# Access Compliance Report

## Public Rights-of-Way

### (Curb Ramps)

Intersection ID: 15932	Main Street: HARTFORD_AV	Cross Street: WESTON_ST	Location: E
ADA ID: EF89D05057A1	Ramp Type: BlendTrans2	Initial Pass/Fail: Fail	Overall Compliance: No
Severity Score: 17.5			
Codes/Mitigation Info/Possible Solution		Field Measurements/Component Compliance

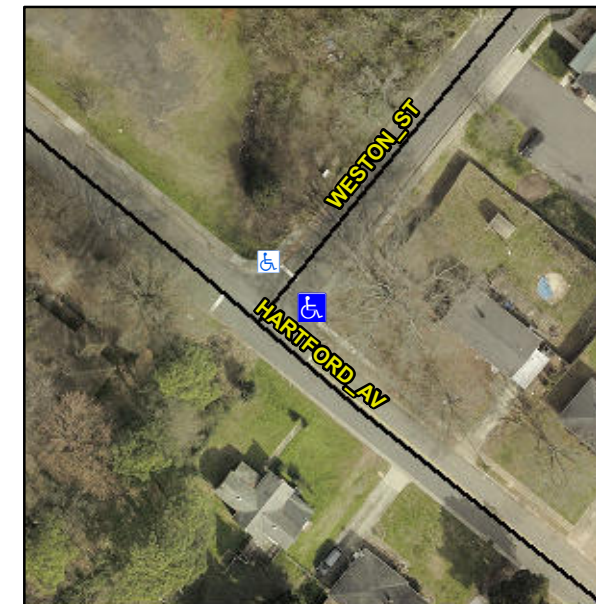
**Remove & Replace Curb Ramp With Two New Directional Ramps or Equivalent.**

**Not Found, R304.5.1**
